MISCELLANEOUS PAPER GL-82-5

ASSESSMENT OF THE LIQUEFACTION HAZARDS RESULTING FROM EXPLOSIVE REMOVAL OF THE BIRD'S POINT-NEW MADRID FUZE PLUG LEVEE

APPENDIX A: REVIEW OF CONCLUSIONS
BY
PROFESSOR H. B. SEED

Review Comments on WES Report

Figure 7. Velocity versus MM intensity in the near field (10 percent increments between the mean (50%) and the limit of observed data (100%))

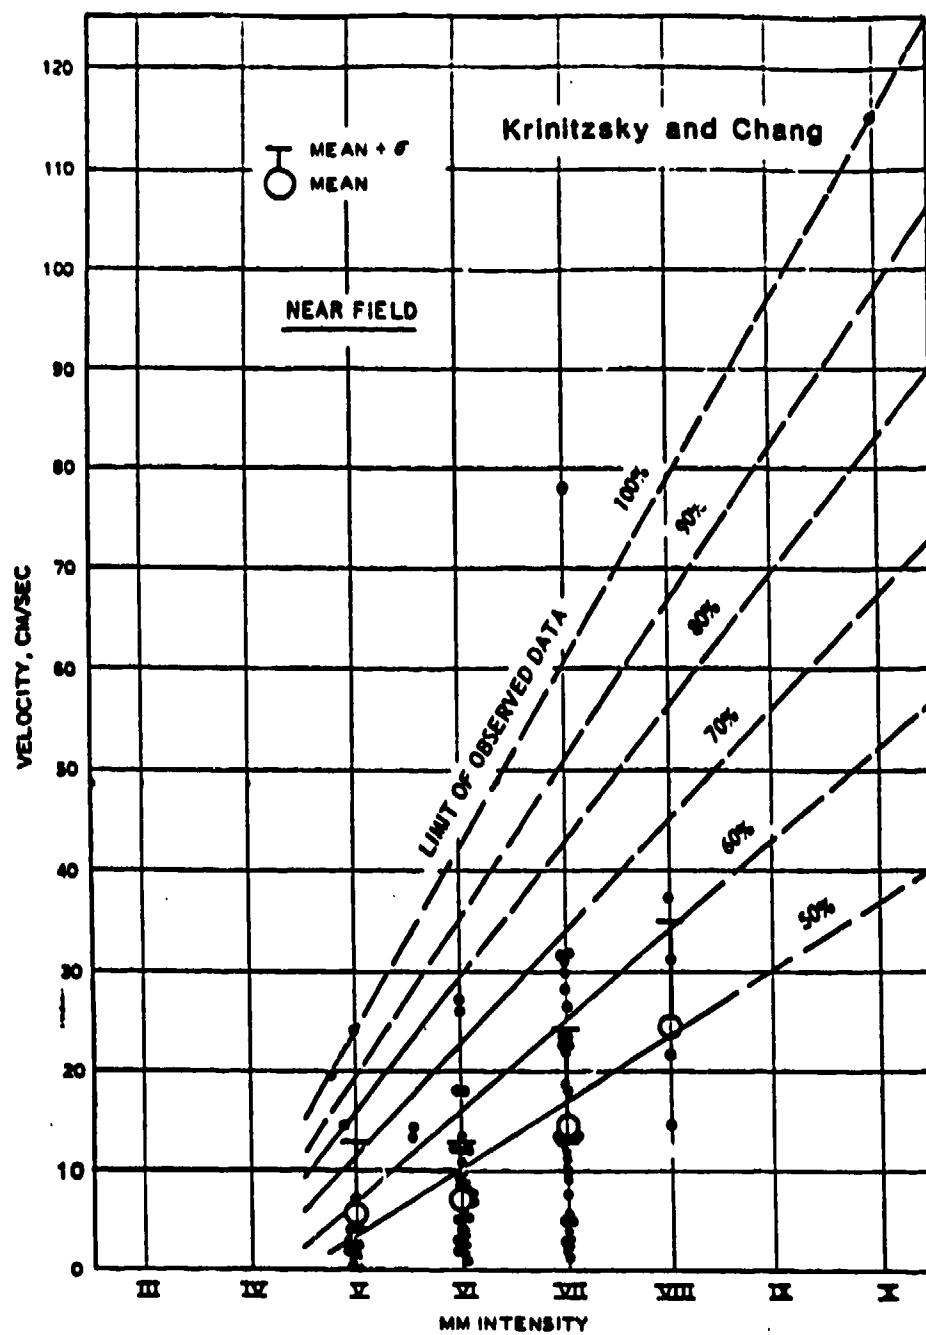
1. The wide scatter of the data relating Intensity with ground motion characteristics. Thus it may be seen from Fig. 7 that Intensity VI is associated with peak ground velocities ranging from 1 to 28 cm/sec. with many sites showing values less than 10 cm/sec.
2. The fact that nothing is known about the soil conditions at the sites where Intensity VI was associated with peak velocities exceeding 10 cm/sec. It could be that the absence of liquefaction at these sites was due to the fact that they were dense sand or clayey soils and has nothing to do with the recorded motion levels. If this were so, then the peak velocity values associated with possibly vulnerable sites would be 1 to 9 cm/sec with a median value of 5 cm/sec.

3. Using the same arguments as those used to conclude that Intensity VI is not associated with soil liquefaction, one must conclude that sites with Intensity VII do have liquefaction potential and, as shown in Fig. 7, for many such sites velocities as low as 1 to 14 cm/sec have been recorded. If liquefaction can occur at these values of peak velocity, the selection of 10 cm/sec as a threshold value below which it can not occur seems to require further support.

Based on the above and the data in the report, I conclude that the threshold value of peak ground velocity of about 10 cm/sec used to evaluate liquefaction susceptibility in this study report is reasonable, and accordingly, that the main conclusions of the report are justifiable and appropriately consistent with the present state of knowledge of vibration-induced liquefaction phenomena.
